Contract #: 04-0120F4Cty: SF/ALA Rte: 80 PM: 13.2/13.9File #: 69.25B**QUALITY ASSURANCE -- NON-CONFORMANCE REPORT****Location:** Changxing Island, Shanghai, P.R. China**Report No:** NCR-000707**Prime Contractor:** American Bridge/Fluor Enterprises, a JV**Date:** 07-Apr-2010**Submitting Contractor:** Zhenhua Port Machinery Company, Ltd (ZPMC), Changxing Island**NCR #:** ZPMC-0674**Type of problem:**

Reference Description: Missed UT indication by QC on Segment 9CE Bottom Plate to Bottom Plate Weld**Description of Non-Conformance:**

Job Name: SAS Superstructure
Document No: 05.03.06-000663

WELD NUMBER: SEG054A-006

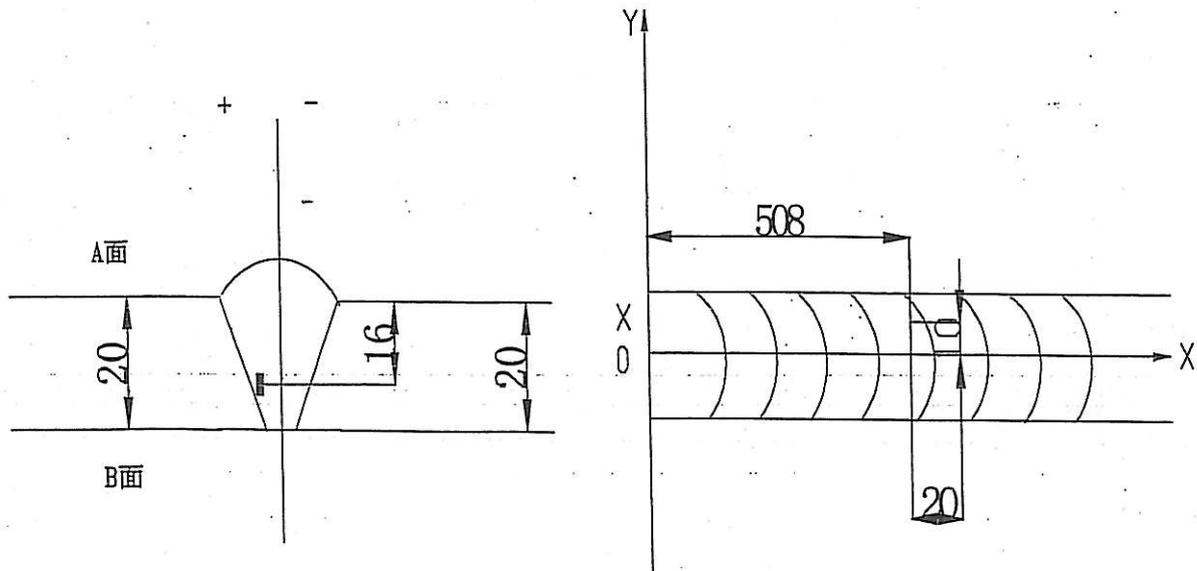
Description of welding discontinuity:

Rejected indication found by ultrasonic inspection is less than the maximum allowance aggregate length.

(UT探伤发现的缺陷总长度小于最大允许长度。) SEG054A-006

Caused:

1. Did not clear the weld pass completely in time.

Disposition :

1. Gouge or grind from nearer side from metal edge ($D \leq 0.65T$, "D" is depth of defects, "T" is thickness of metal) to remove all defects;
2. Follow repair WPS for joint preparation, preheat, and weld deposit;
3. Verify with VT no defects remain in the weld joint prior to welding;
4. Grind the repaired area flush with base metal or the adjacent weld;
5. Perform UT inspection to the weld along with 50mm on each end of the repair area;
